ZRD1/CCD1 Response Form

Street Name Reade Street

I, herewith respectfully request Code Determination related to egress for the proposed first floor and cellar Eating and Drinking Establishment based on the following assessment:

DRAWING TITLE:
PROPOSED CELLAR & 1ST PLANS

1 PROPOSED CELLAR PLAN
SCALE: 1/8" = 1'-0"

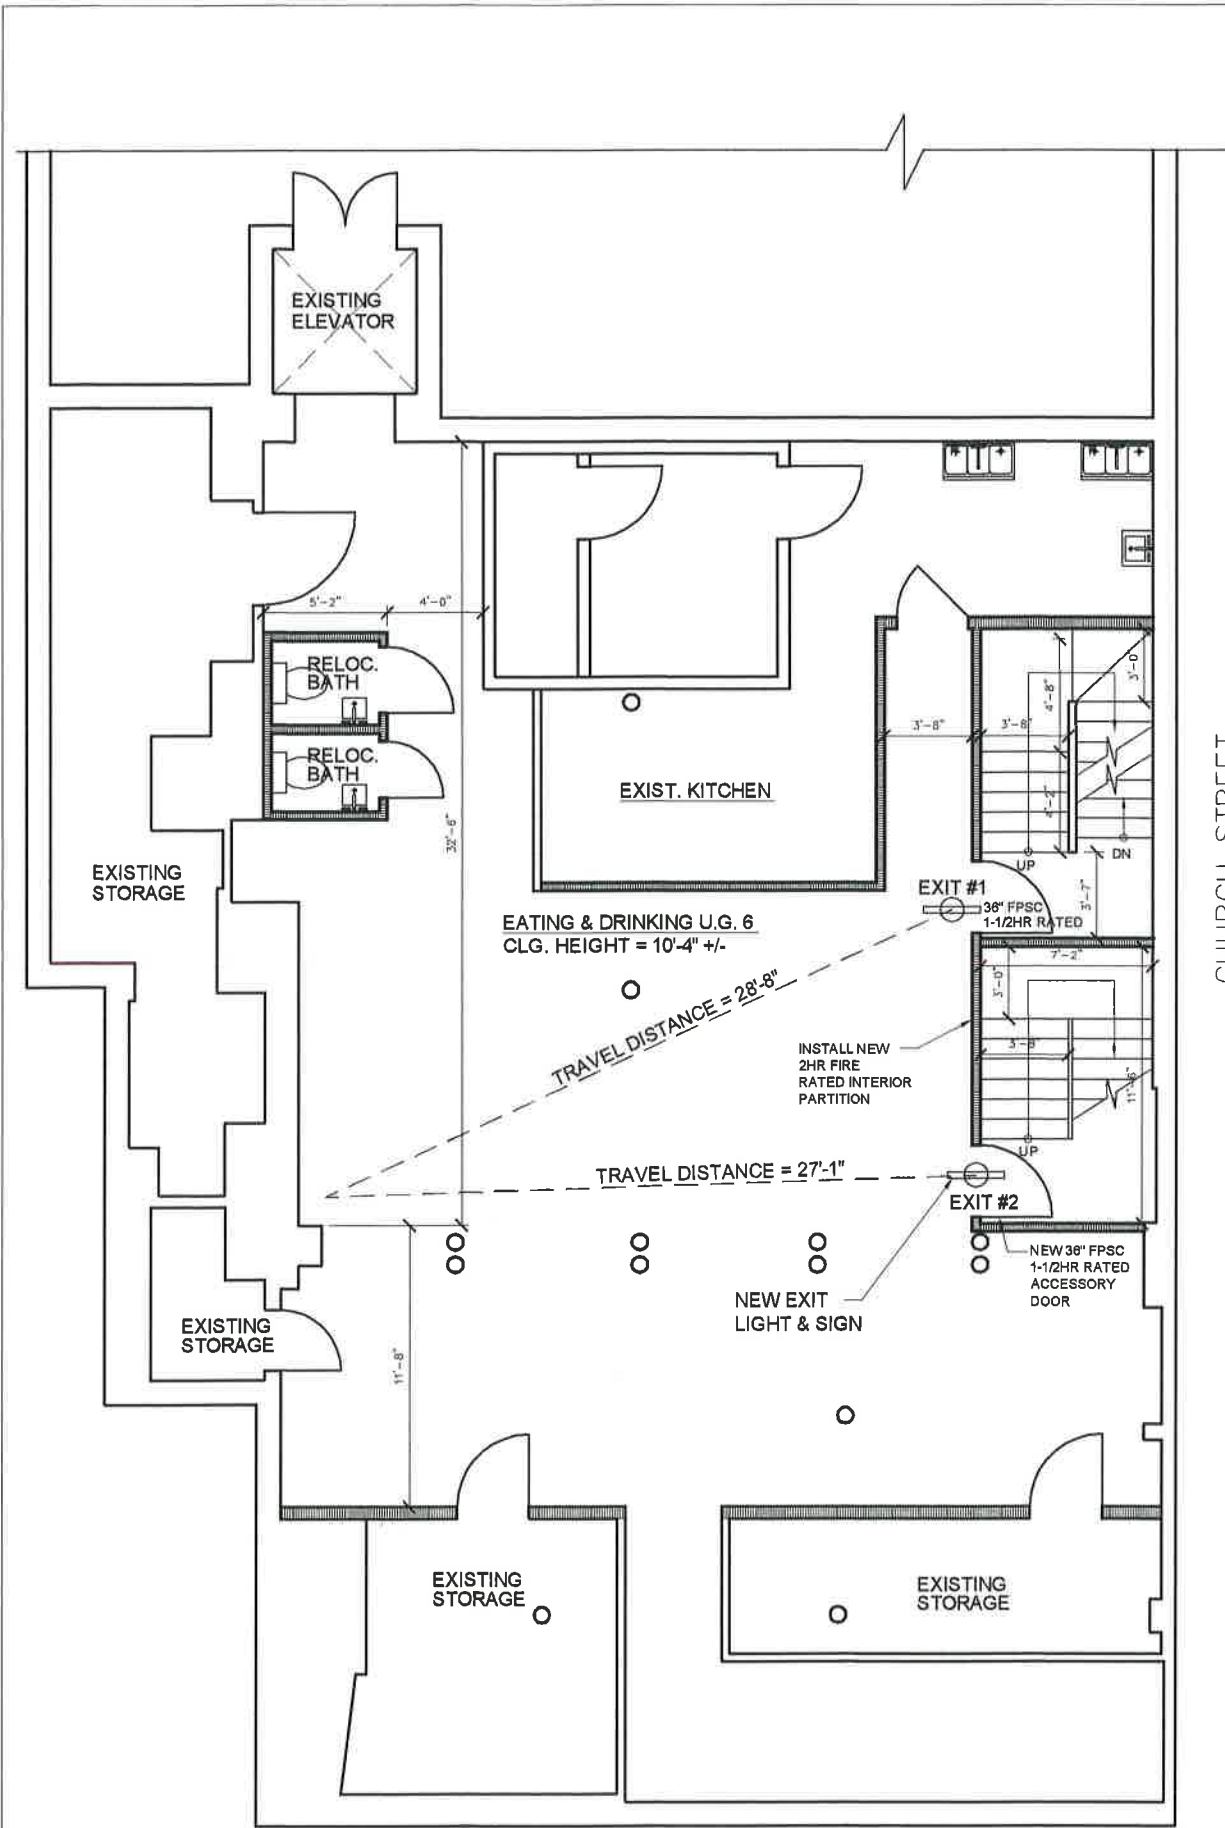
3. We propose to provide a second means of egress from the cellar via a 44" wide steel stair and 2-hour rated enclosure to the existing residential lobby and street (see drawings). The total occupancy in the cellar will be 30 occupants.

4. A restrictive declaration will be filed with regard to the cellar emergency egress passing through the residential lobby.
5. The proposed stair from cellar to first floor will not encroach on the existing sidewalk vault.

OK to accept as stated & shown with the following:

- i) From cellar: Exit #1, which is considered the primary exit from the cellar, runs up to the mid-section of the 1st floor, then travels with a distance of 18'-10" (with sprinkler heads @ 6' o.c. along the path of travel) exiting to the street. Exit #2, which is considered the secondary exit and to be used for emergency use only (shared with residential tenants of adjoining building with recorded easement & restrictive declaration required).
- ii) From 1st floor: Exit #1, which exits directly to the street and is considered the primary exit, is acceptable. Exit #2, which is considered the secondary exit and to be used for emergency use only (shared with residential tenants of adjoining building with recorded easement & restrictive declaration required).

2 PROPOSED 1ST FLOOR PLAN
SCALE: 1/8" = 1'-0"

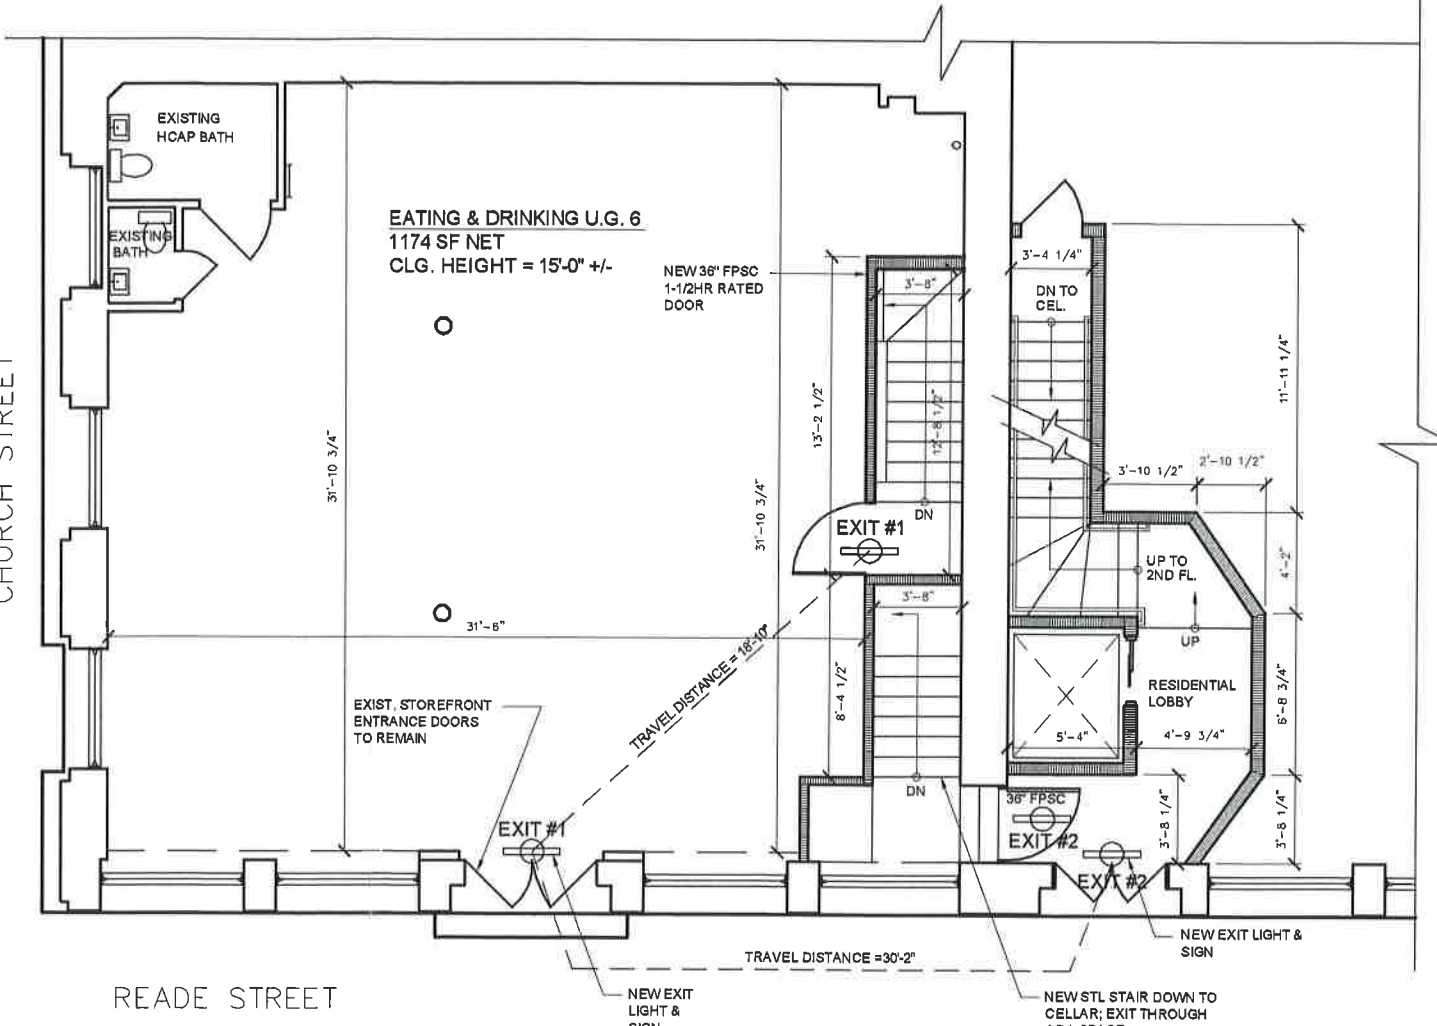
6. Please note that the cellar and the first floor are fully sprinklered.
7. The existing first floor enclosed stair will be modified to show primary travel distance at ~~21'-0"~~ ^{18'-10"}.

8. We therefore request that the second means of egress for the cellar occupants be permitted to exit through the existing lobby and the primary exit through the existing 2hr rated stair.
